Site Survey of Selected Items
for
Compliance with the Americans with Disabilities Act
(ADAAG)
and
Title 24 of the CBC

The site survey of James Monroe High School was conducted on December 1, 2006 during a spot check for compliance with the Americans with Disabilities Act Guidelines (ADAAG) and Title 24 of the CBC

Facility Name: James Monroe High School

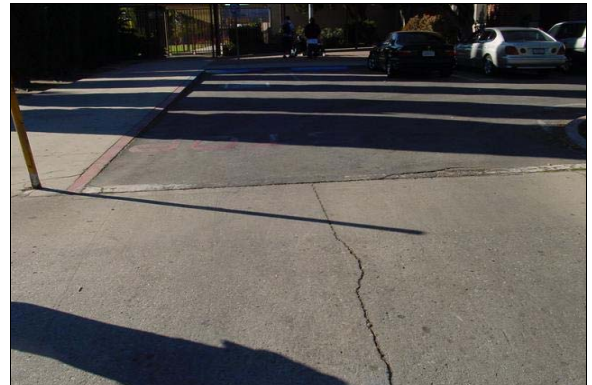
Finding: James Monroe High School provides services to students in grades 9-12. The facility was inspected by Disability Access Consultants, Inc., on December 1, 2006. This is a report of selected items and is not intended as a full report.

Full Rec Any renovation or new construction that occurred after January 26, 1992, is subject to meet full code specifications for the California Building Code and ADAAG requirements. All recommendations in this report are based on ADAAG and CBC title 24 requirements. Consult with your design professional to determine which elements are affected by these requirements. It is recommended that Disability Access Consultants, Inc. is consulted for inspection of any new construction or renovation at the facility.

Boys Restroom Building C

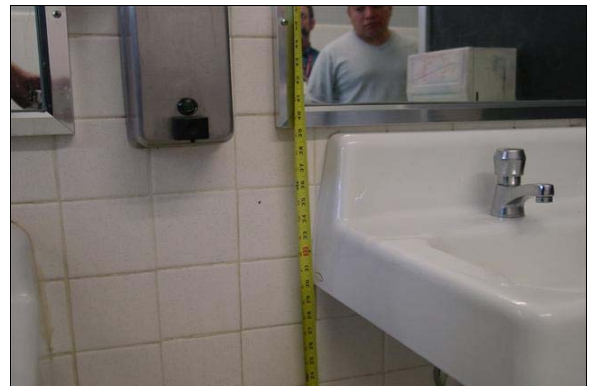
Finding: The bottom edge of the reflecting surface of the mirror in the restroom is 40 3/4 inches above the finished floor.

Full Rec Lower the mirror in the restroom so that the bottom edge of the reflecting surface is no higher than 40 inches above the finished floor and the topmost portion of the reflecting surface extends at least 74 inches above the finished floor (see ADAAG A4.19.6). A single, full-length mirror is recommended since it can accommodate all people. Make certain to provide a minimum clear floor space in front of the mirror of 30 inches in width and 48 inches in length.

Girls Restroom Building B

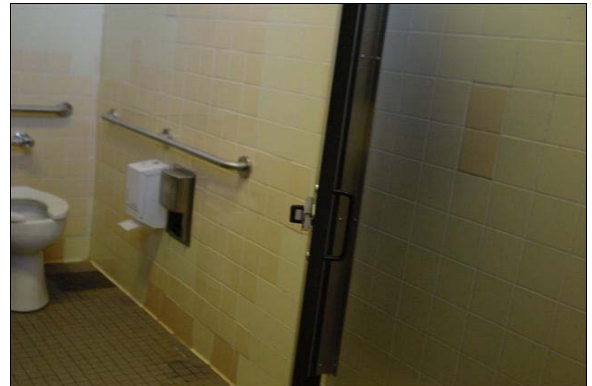
Finding: The door to the stall designated to be accessible in the restroom does not close automatically or have accessible hardware.

Full Rec Provide an automatic door closer, spring hinge, pull bar or accessible handle mounted on the inside of the stall door to the stall designated to be accessible in the restroom (see ADAAG A4.17.5). Accessible hardware on the inside and outside of the stall designated to be accessible door shall be equipped with a loop or U-shaped handle mounted immediately below the latch. The latch shall be flip-over style, sliding or other hardware not requiring grasping or twisting. Make certain that the inside and outside door hardware is mounted no more than 48 inches above the finished floor (see CBC 115B.7.1.3 and ADAAG 4.13.9).

Girls Restroom Building B

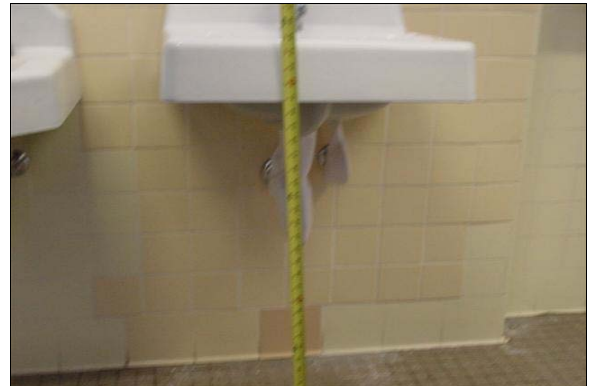
Finding: The height of the rim surface of the lavatory designated to be accessible in the restroom is greater than 34 inches above the finished floor.

Full Rec Relocate or replace the lavatory designated to be accessible in the restroom to provide a maximum rim surface height of no greater than 34 inches above the finished floor (see ADAAG 4.19.2).

Girls Restroom Building T

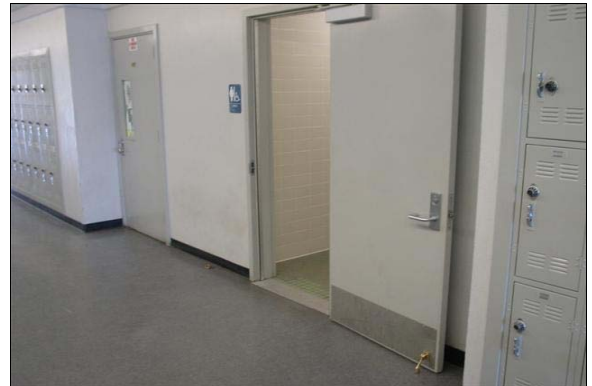
Finding: There is signage indicating accessibility on the entry door to the restroom. The signage is centered 60 inches above the floor on the latch side of the entrance door and includes Braille and raised lettering, gender use symbol and the ISA symbol.

Girls Restroom Building T

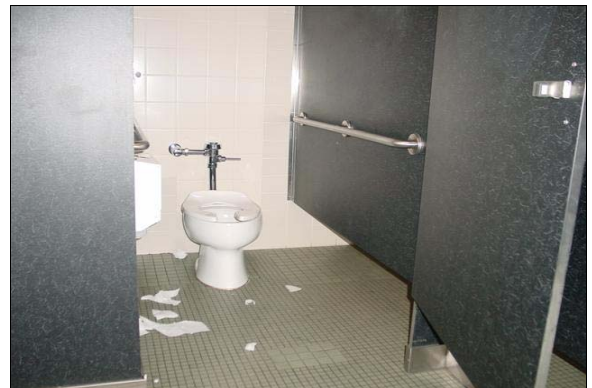
Finding: The door in the alternate stall designated to be accessible in the restroom does not have appropriate accessible hardware.
